# **Glenorchy Planning Authority**

## 5 PROPOSED USE AND DEVELOPMENT – 12 LOT SUBDIVISION PLUS ROAD AND PUBLIC OPEN SPACE – COACH ROAD, CHIGWELL

<b>Application No.:</b>	<b>PLN-25-153</b>
<b>Applicant:</b>	<b>MC Planners</b>
<b>Owner:</b>	<b>David Stewart Homes Pty Ltd</b>
<b>Zone:</b>	<b>General Residential Zone and Landscape Conservation Zone</b>
<b>Use Class</b>	<b>Subdivision (no use class)</b>
<b>Application Status:</b>	<b>Discretionary</b>
<b>Discretions:</b>	<b><i>8.6.1 Lot Design P1, P2, and P4;</i> <i>8.6.2 Roads P1,</i> <i>22.4.4 Landscape protection P1 and P2,</i> <i>22.5.1 Lot Design P1 and P4,</i> <i>C6.10.1 Lot design on a Local Heritage Place P1,</i> <i>C7.6.2 Clearance within a priority vegetation area P1.1 and P1.2,</i> <i>C7.7.2 Subdivision within a priority vegetation area P1.1 and P1.2,</i> <i>C8.6.1 Development within a scenic protection area P1.1 and P1.2.</i></b>
	<b>(The proposal meets all other applicable standards as demonstrated in the attached appendices)</b>

## SECTION - CUT BATTER

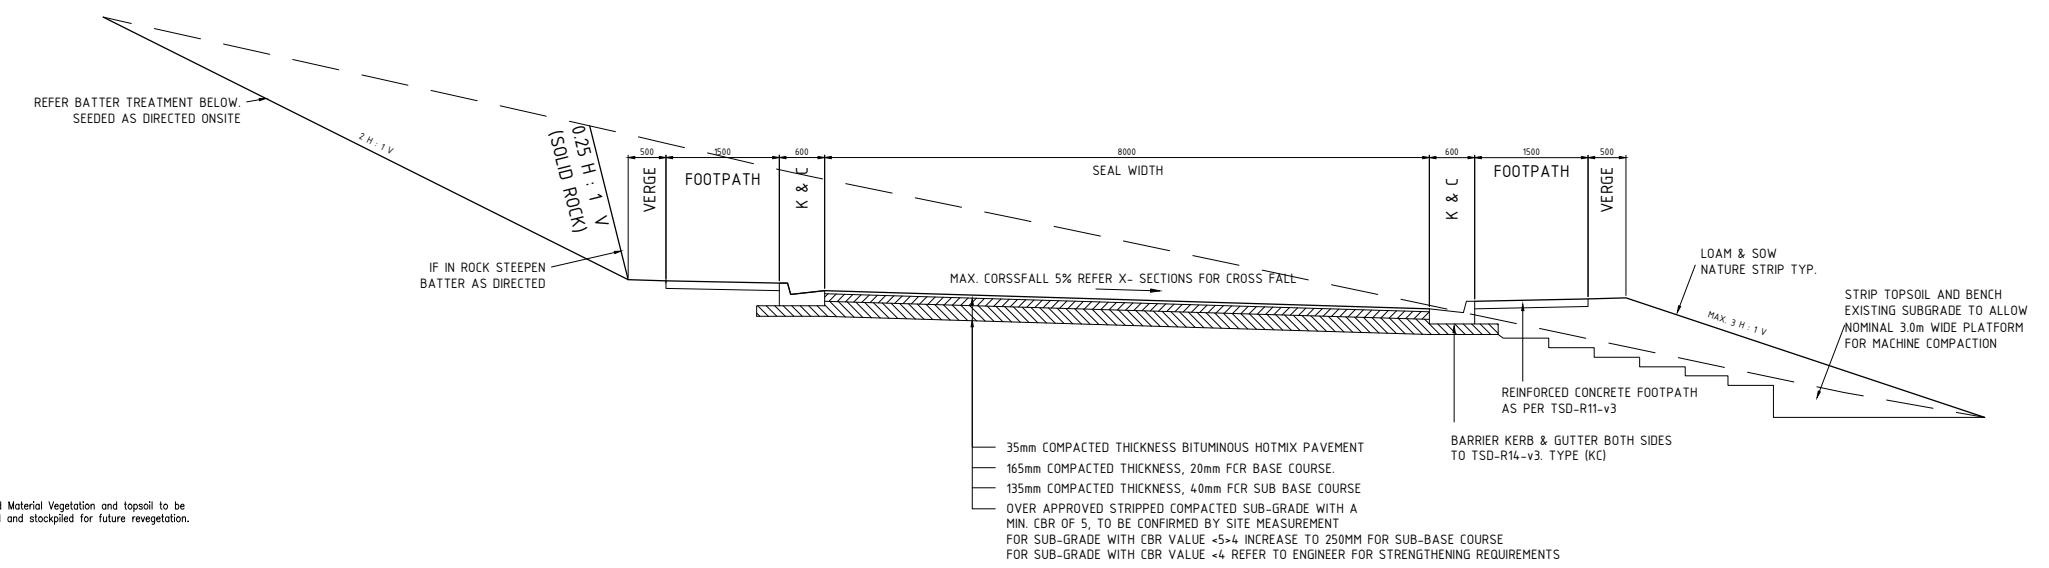
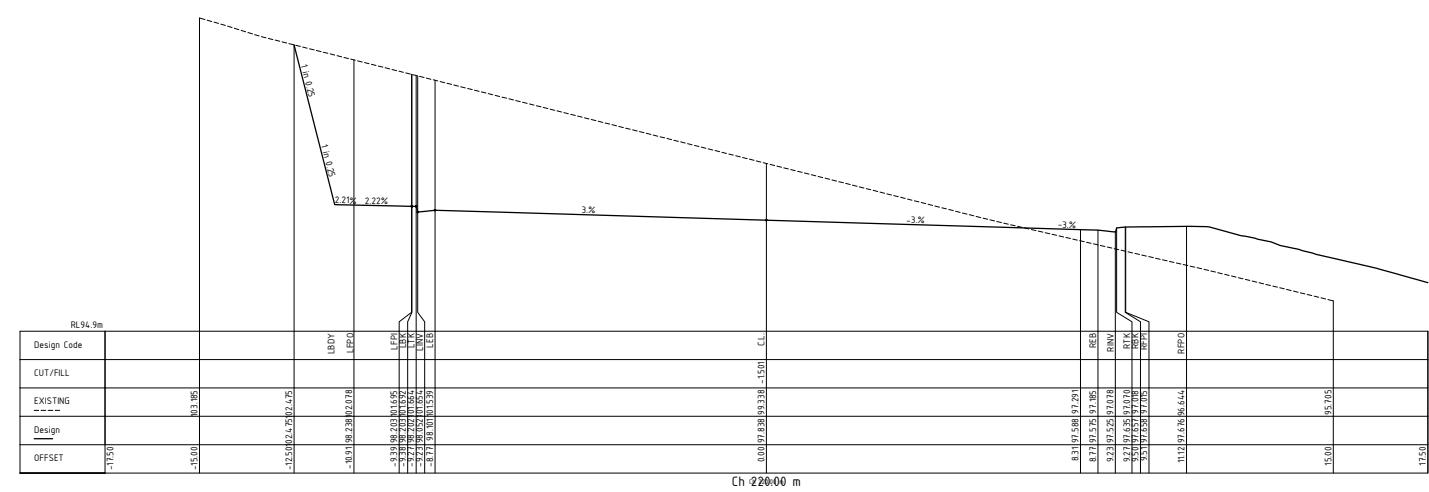
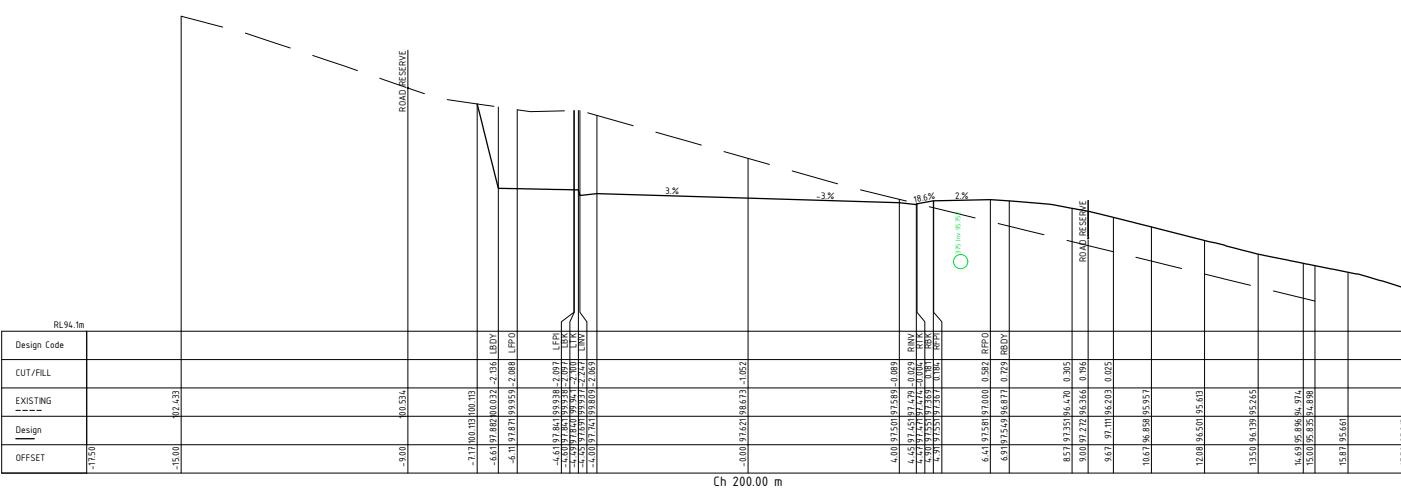
With regard to sub-clause P1.2(e), cut and fill is required in order to construct the proposed road. As shown on the cross sections provided in the civil plans included in the application, predominantly cut is required in order to construct road, although some fill would also be used on the lower side of the road. Given the height of the proposed cut (up to approximately 4.5m) there is potential for this work to have an impact upon the scenic value of the scenic protection area.

Therefore, a condition of approval should require landscaping to be provided where cut and fill is required. The condition should require a landscaping plan for these areas to be prepared by a suitably qualified person. The plan should be consistent with the scenic values and management objectives. The plan should also be consistent with the BHMP provided for the subdivision.

The civil plans suggest that a “barrier fence” is required at top of the batter embankment that would be created as a result of the proposed cut. The plans show that the barrier fence would be approximately 100m long and it may therefore potentially have some impact upon scenic values. Therefore, the landscaping plan should also include this barrier fence to ensure that this potential impact is mitigated.
